GFA AIRWORTHINESS DIRECTIVE

TYPE AFFECTED: DG-400 all Serial Numbers.

SUBJECT: a: Modification of the starter motor mount and b: The engine support brackets. c: Failure of fuel lines.

GFA AD 453	ISSUE: 2	26 August, 1996	Page 2 of 19
-------------------	-----------------	------------------------	---------------------

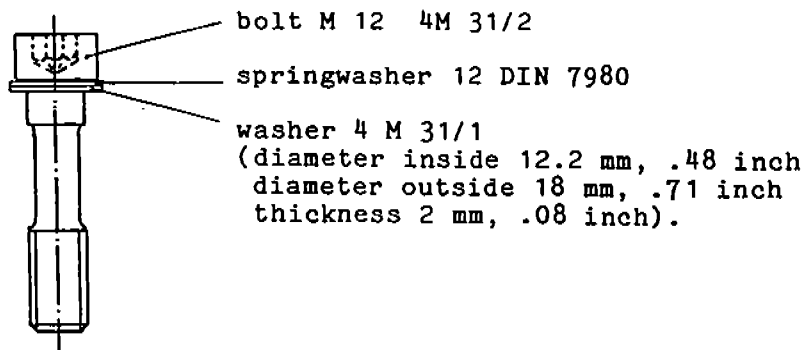
Modification: Place a washer 4 M 31/2 underneath the the springwasher.

14. Mounting of the starter motor: Bosch type DG

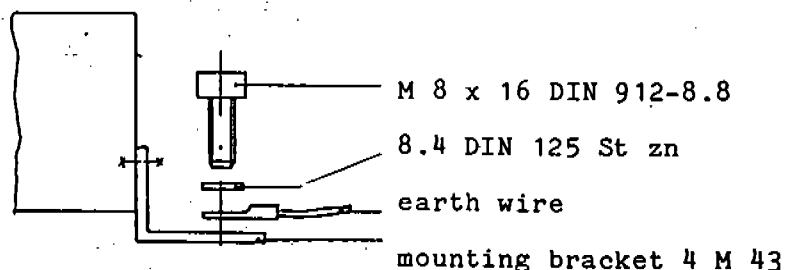
Modification: Replace the two mounting bolts (6) M 8 x 25 DIN 912-8.8 by M 8 x 22 DIN 912-8.8

Mount starter motor with bolts (5) and (6) and a washer 8.4 DIN 125 St under each bolt head.

b) Bosch American E-Starter

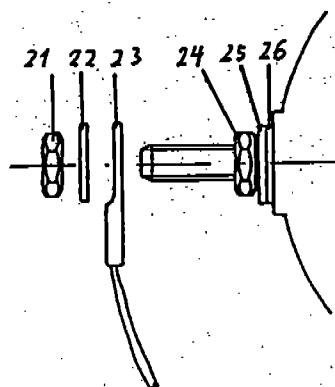
Modification:

Fix nut (24) on to the bolt protruding out of the starter.
 Put on positive wire (23) and springwasher (22) and screw
 on nut (21). Use an open end spanner 11 mm (7/16 inch).

sketch 1

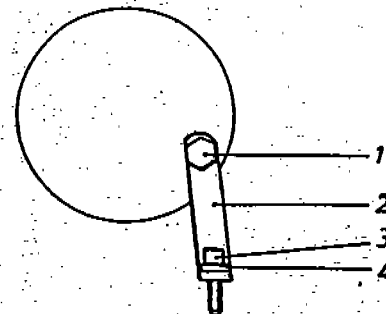
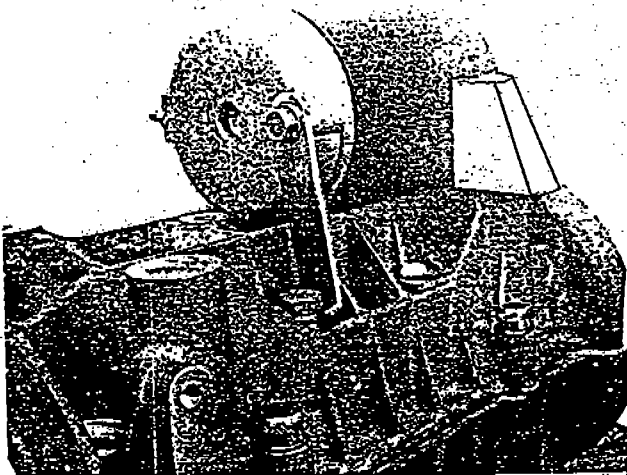
Remove bolt (3) and springwasher (4) from the engine (see photo). Fix the holder 4 M 70 to the starter motor with screw (1) (see sketch 1). This screw cuts the thread into the hole of the starter motor.

Sketch 2

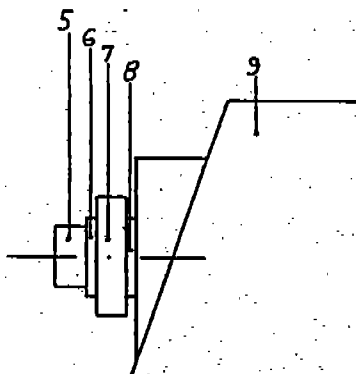
- Replace the two mounting bolts M 8 x 25 DIN 912-8.8 by bolts M 8 x 22 DIN 912-8.8.
- Place a distance washer 8.4 DIN 522
(inside diameter 8.4 mm - 0.33 inch)
(outside diameter 14 mm - 0.56 inch)
(thickness 0.3 mm - 0.01 inch)
in the cutout of the starter motor flange.

Mount starter according to sketch 2 to the blocks 4 M 5.
